Access Compliance Report

Public Rights-of-Way

Intersection ID: 12739	Main Street: N_MCDOWELL_ST	Cross Street: E_8TH_ST	Location:	N
ADA ID: CFE09FE52692	Ramp Type: PerpDiag	Initial Pass/Fail: Fail	Overall Compliance: No	Severity Score: 25

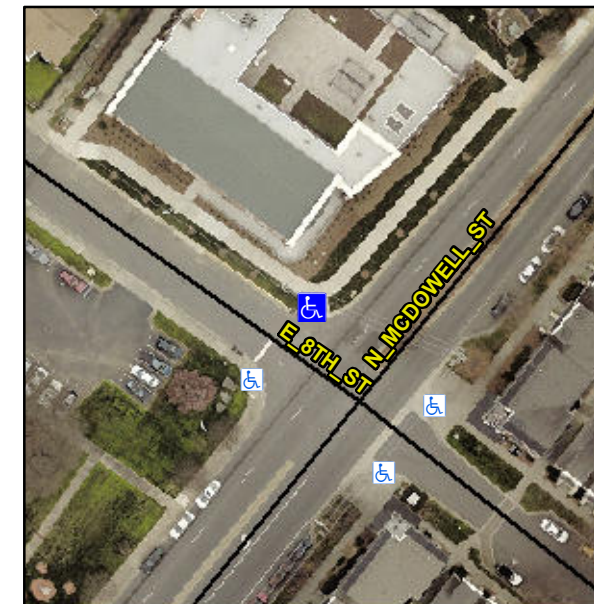
Not Found, R304.2.2, R304.5.3

Compliance	Description	Data	Compliance	Description	Data
N/A	Ramp Length (in)	70.0	No	Ramp Slope (%)	9.1
Yes	Ramp Width (in)	55.0	No	Ramp XSlope (%)	5.1
N/A	Flare Type LT	N/A	N/A	Flare Type RT	N/A
N/A	Flare Slope LT (%)	N/A	N/A	Flare Slope RT (%)	N/A
N/A	Flare Traversable LT?	N/A	N/A	Flare Traversable RT?	N/A
N/A	Landing Length (in)	N/A	N/A	DWS Provided?	N/A
N/A	Landing Width (in)	N/A	N/A	DWS Contrast?	N/A
N/A	Landing Slope (%)	N/A	N/A	DWS Length (in)	N/A
N/A	Landing X Slope (%)	N/A	N/A	DWS Full Width?	N/A
N/A	Landing Curb? (Y/N)	N/A	N/A	DWS Offset (in)	N/A
N/A	Shared Landing?	N/A			
N/A	Gutter Ponding?	N/A	N/A	Gutter Slope (%)	N/A
N/A	Gutter Lip Ht (in)	N/A	N/A	Gutter X Slope (%)	N/A
N/A	Painted X Walk1?	No	N/A	Painted X Walk2?	No
	X Walk 1 Direction	To SW		X Walk 2 Direction	To SE
N/A	X Walk 1 Width (in)	N/A	N/A	X Walk 2 Width (in)	N/A
	X Walk 1 Slope (%)	0.5		X Walk 2 Slope (%)	0.1
	X Walk 1 X Slope (%)	1.6		X Walk 2 X Slope (%)	1.2

Remove & Replace Curb Ramp With Two New Directional Ramps or Equivalent.
